TO: Madeleine Reinke, Kimley-Horn and Associates, Inc.
FROM: Cynthia Thye, Planner 1
DATE: December 31, 2025
SUBJECT: SP25-119: Lincoln Professional Park L2 - 7 Brews Coffee – Site Plan
Review Comments 02

LINCOLN PROFESSIONAL PARK FILING NO. 1
LOT 2, PARKER, CO
7 BREW - SITE PLAN
COVERSHEET

LINCOLN PROFESSIONAL PARK FILING NO. 1
LOT 2, PARKER, CO
7 BREW - SITE PLAN
SITE PLAN

1 EXTERIOR ELEVATION - NORTH
3/8" = 1'-0"

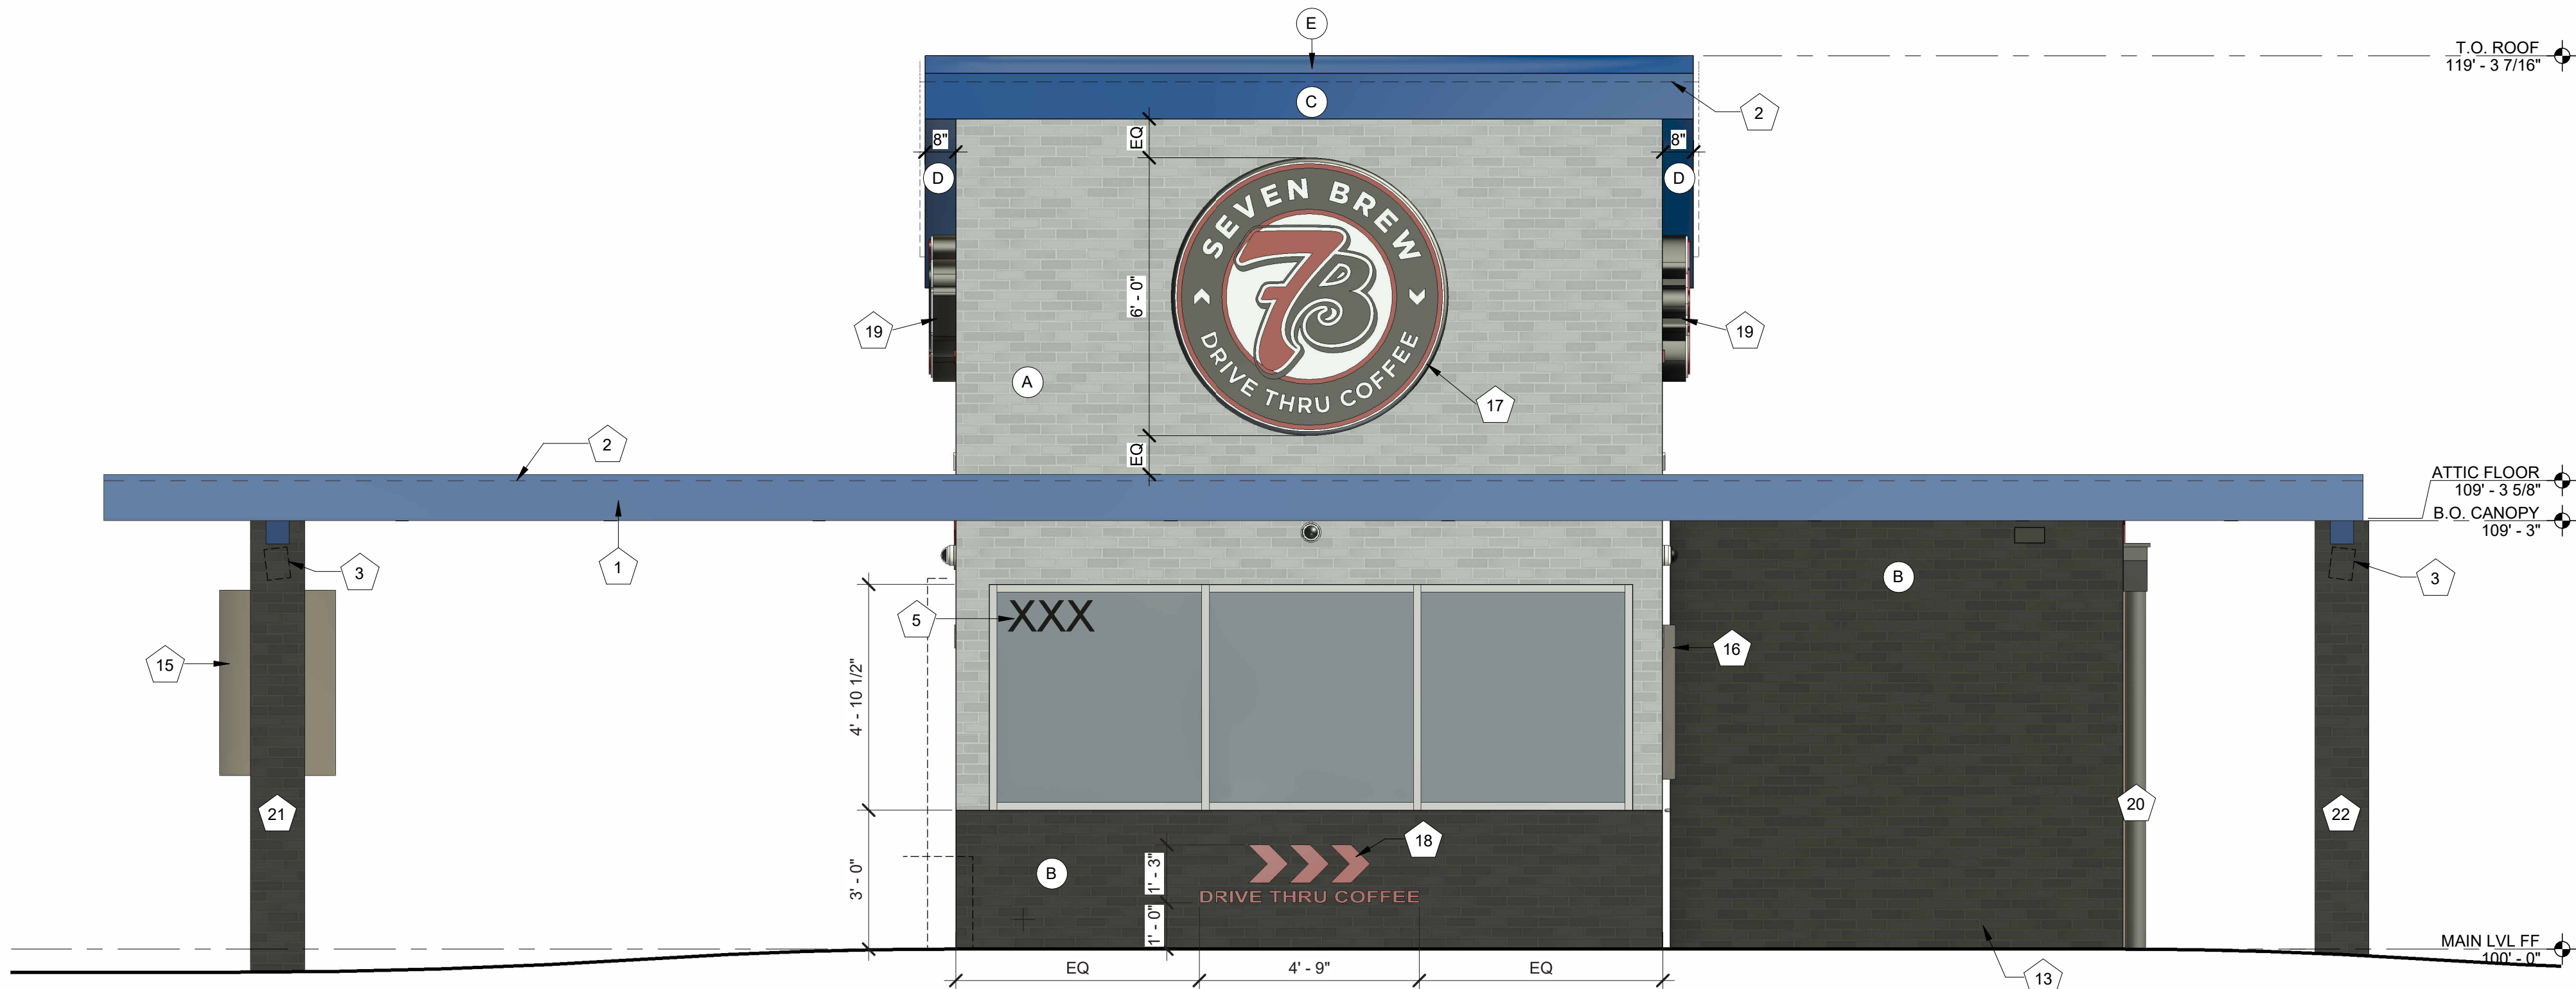
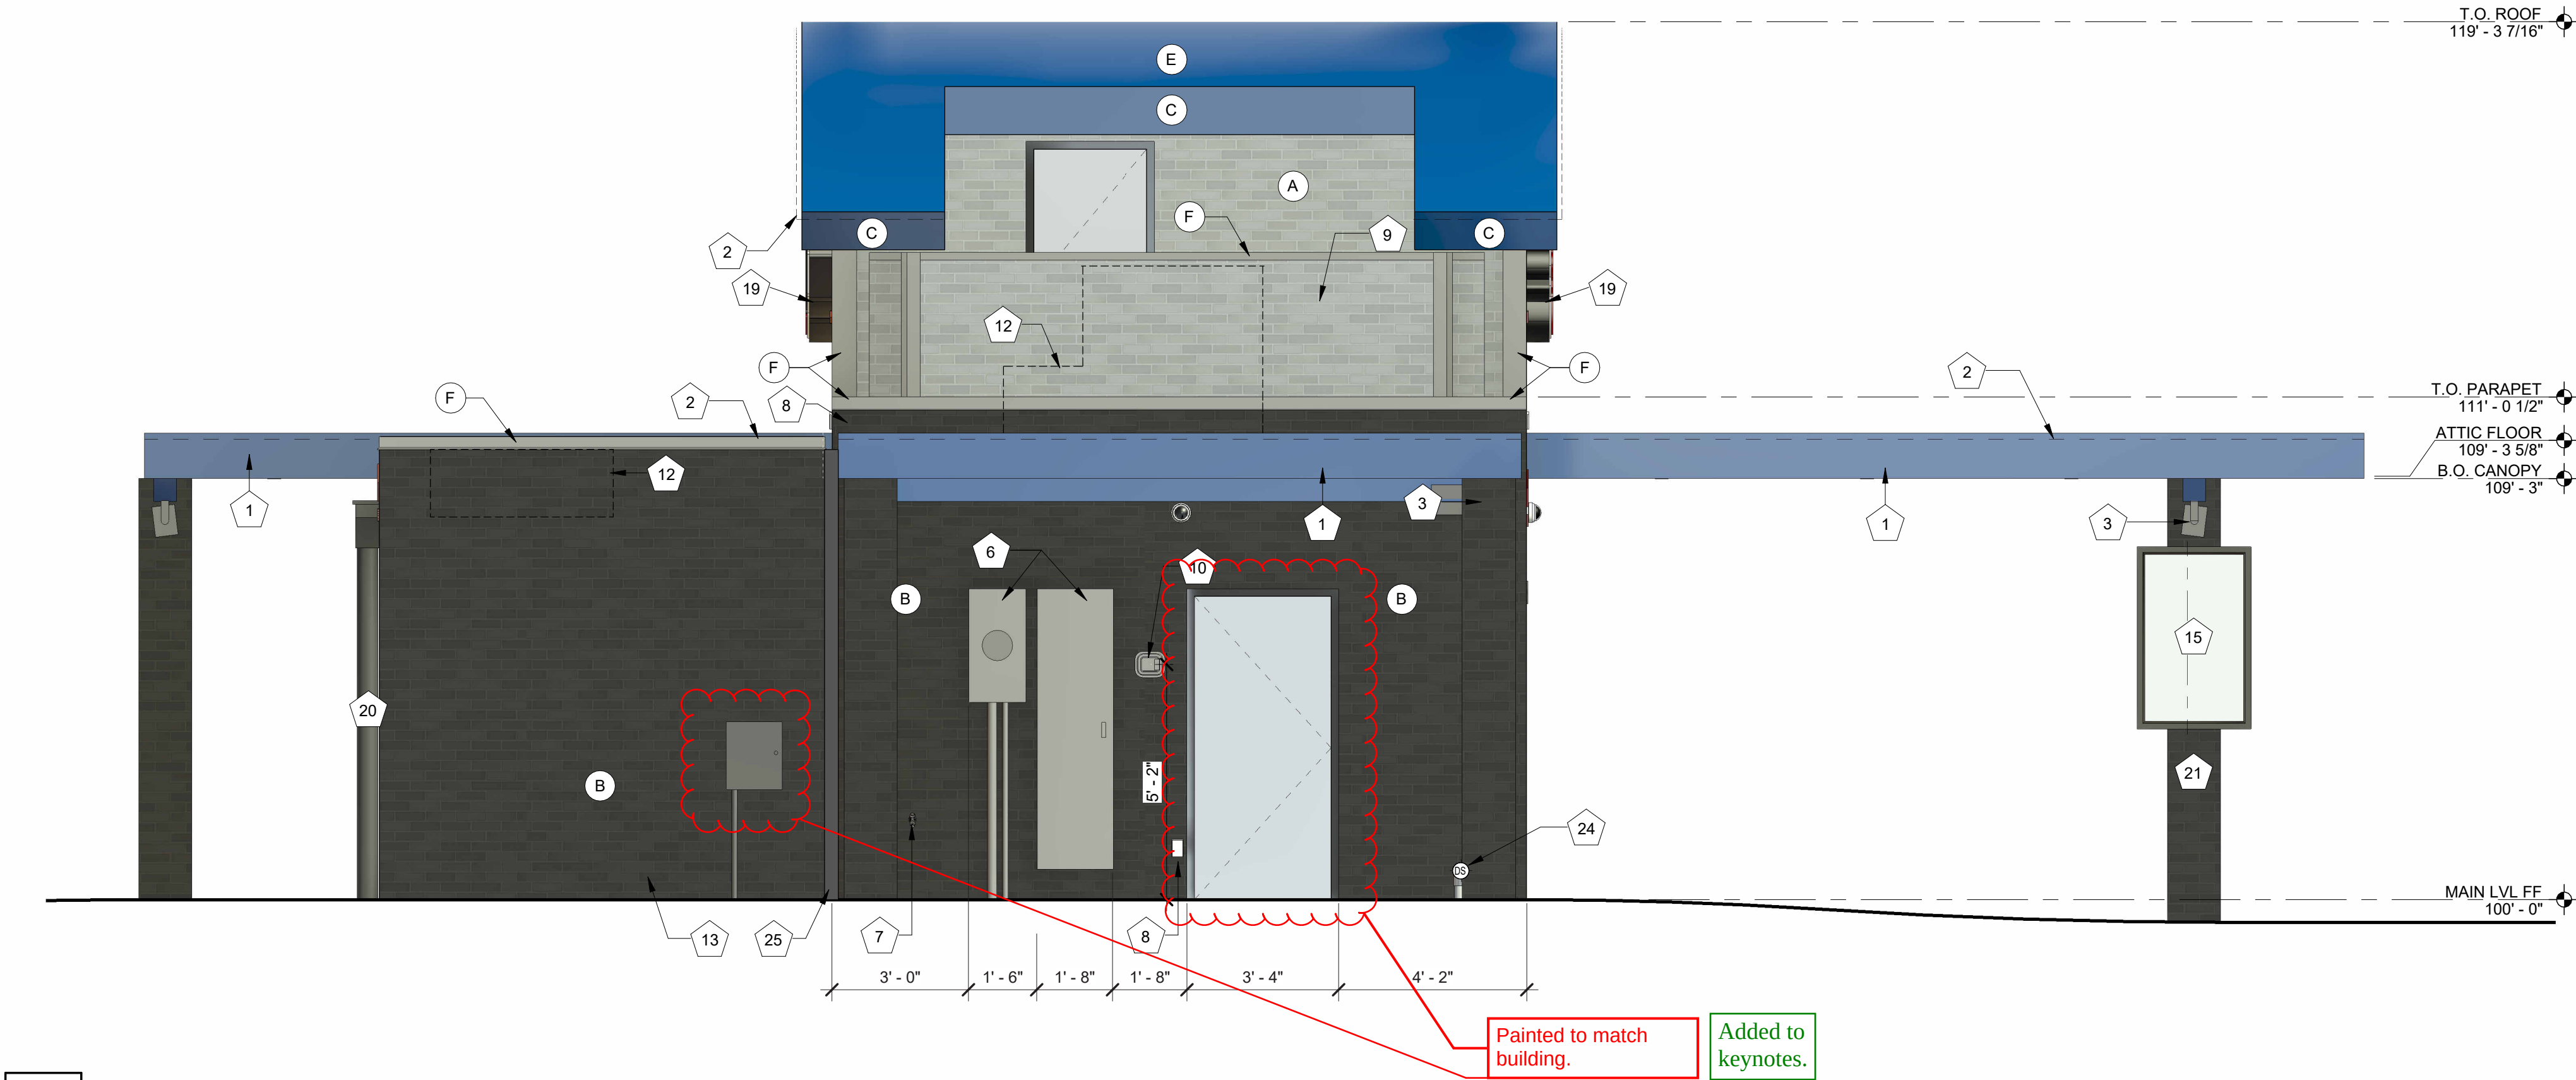
Add percent of each material.

Add Glass to Legend

Additional sheet added with this information.

3 TRASH ENCLOSURE - FRONT ELEVATION
3/8" = 1'-0"

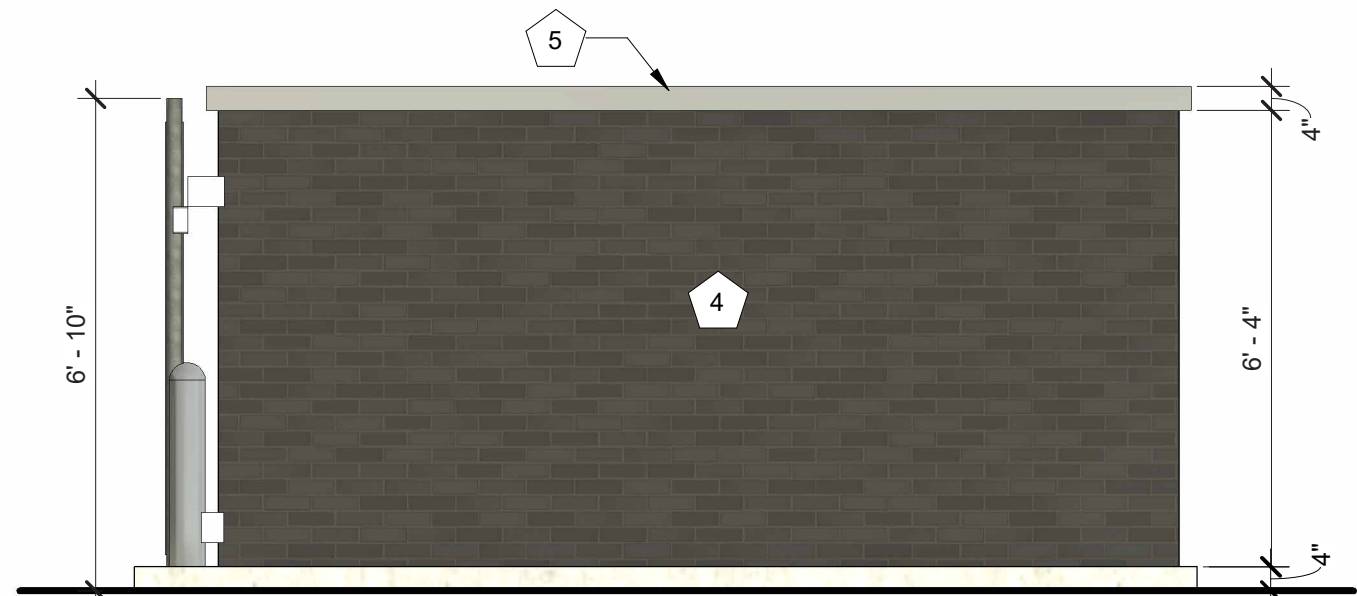
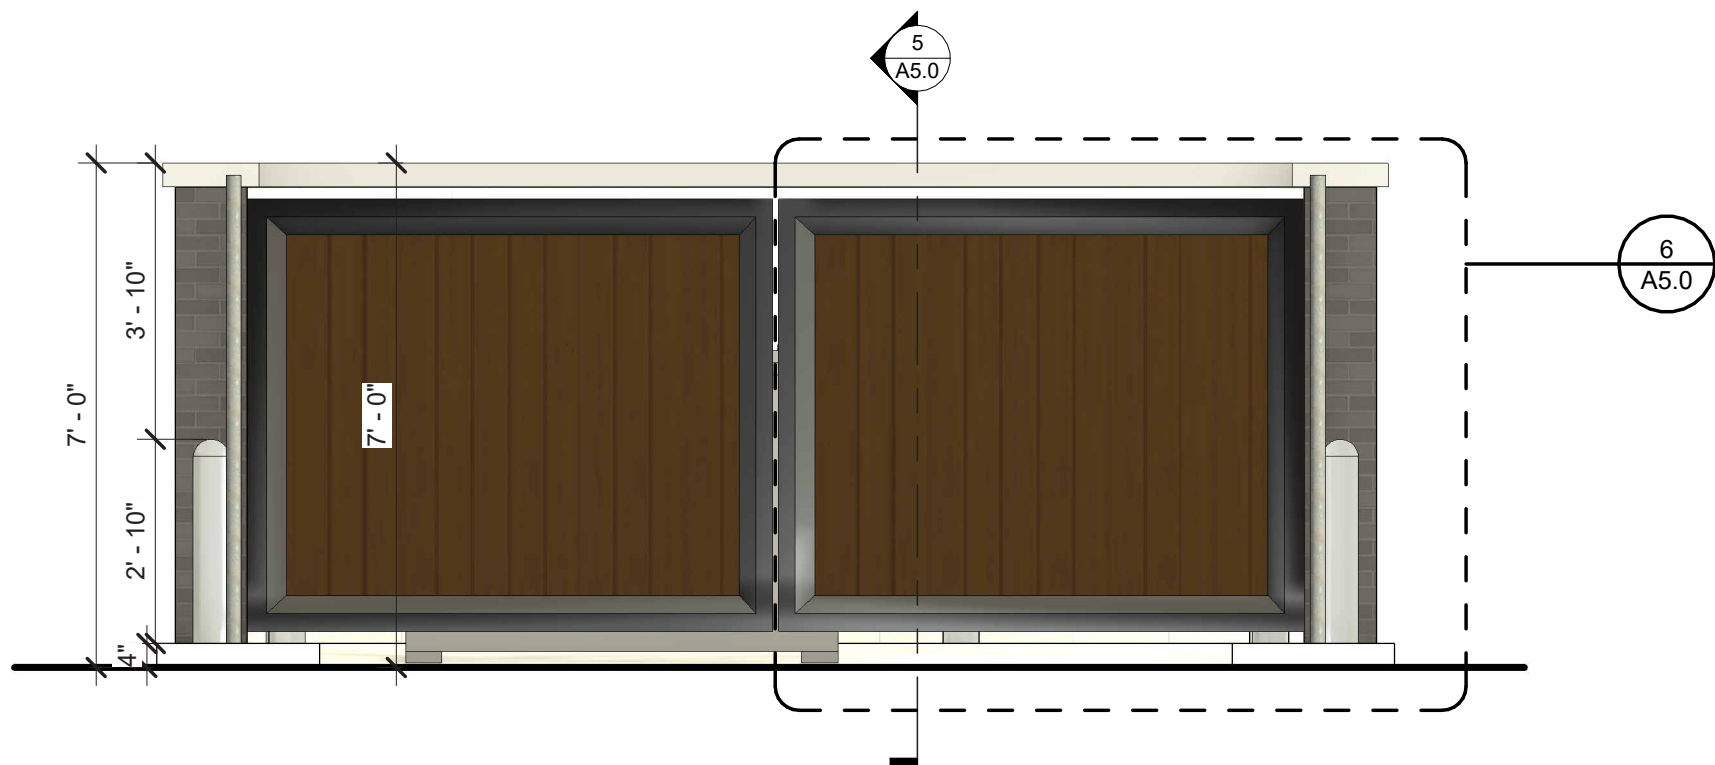
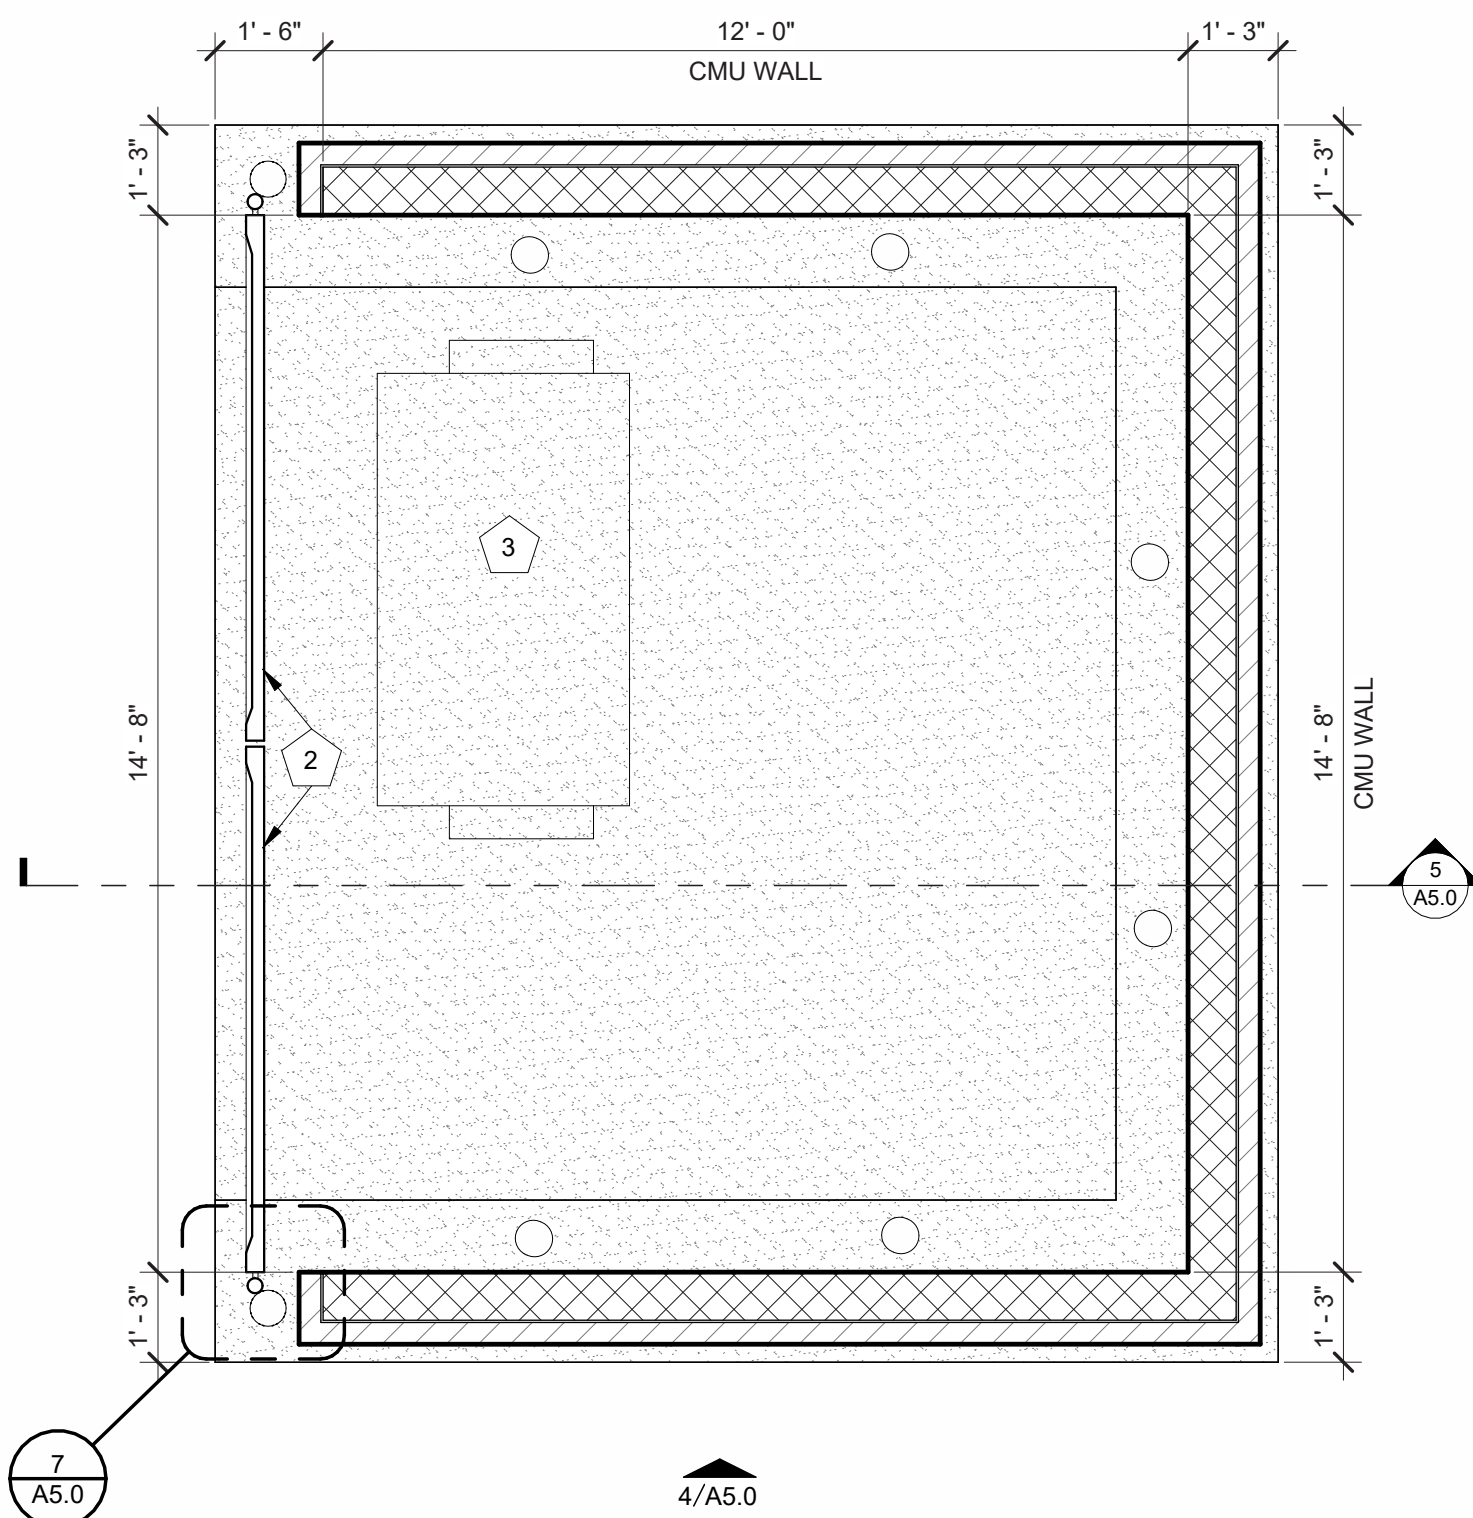
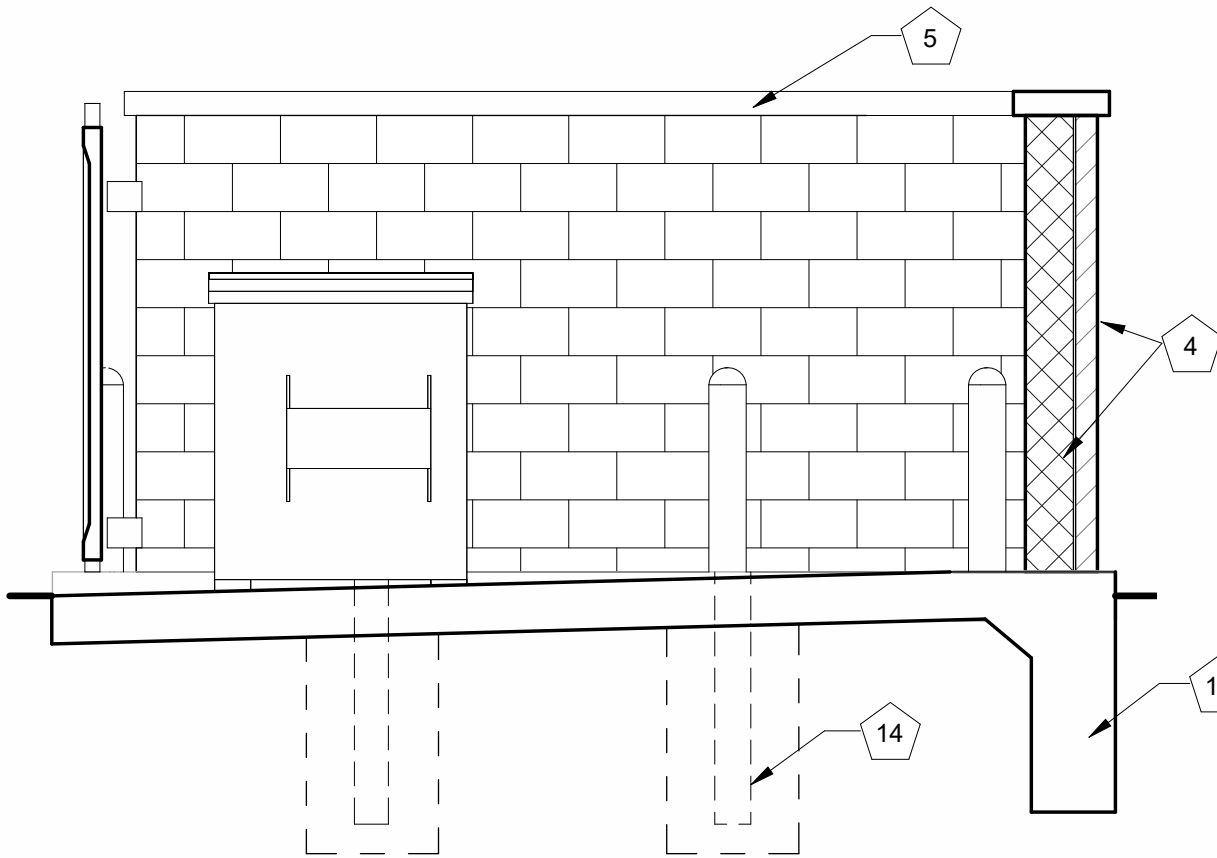
Revise trash enclosure doors to steel painted to match primary structure. For maintenance and durability, these doors will wear easily.

Revised, see sheet A5.0.
